Recall Bulletin

PRODUCT SAFETY RECALL

SUBJECT: 03006 - ELECTRIC OUTSIDE REARVIEW MIRROR SWITCH SHORT CIRCUIT

**MODELS: 1997 CHEVROLET BLAZER, SUBURBAN
 1998 CHEVROLET C/K EXT. CAB PICKUP, ASTRO VAN, SUBURBAN
 1997 GMC JIMMY, SUBURBAN
 1998 GMC SIERRA EXT. CAB PICKUP, SAFARI VAN, SUBURBAN
 EQUIPPED WITH ELECTRIC OUTSIDE REARVIEW MIRRORS**

1235673

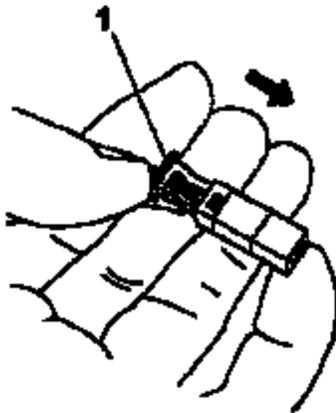
7. Take the two wires and terminals removed from the harness electrical connector and insert them in the two cavity loose connector provided in the recall kit.
 - o Insert the BROWN wire (1) in cavity "B".
 - o Insert the ORANGE wire (2) in cavity "A".
8. Verify that both terminals are locked in the connector by LIGHTLY pulling on the wire.

1235674

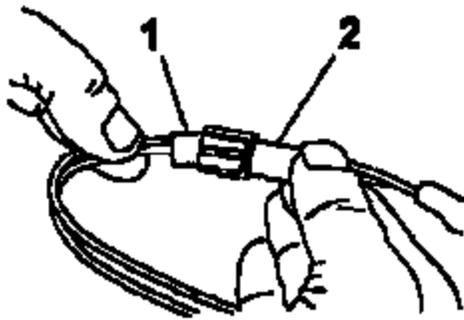
9. Insert the gray terminal position assurance (1) included in the recall kit into the end of the connector where the two wires stick out. When properly installed a "click" type sound will be heard.

1235676

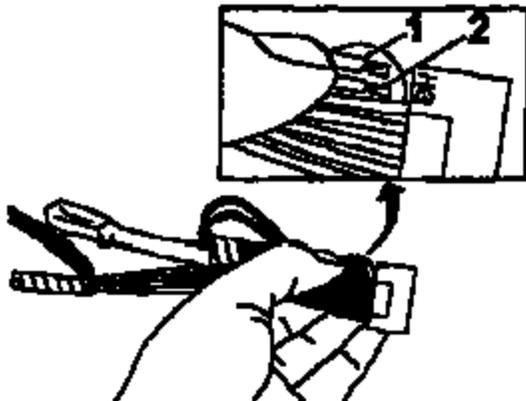
10. Take the new two-cavity connector (1) that you just installed the two wires into, and plug it into the two-cavity connector (2) on the fused wiring harness included in the recall kit. When properly installed a "click" type sound will be heard.
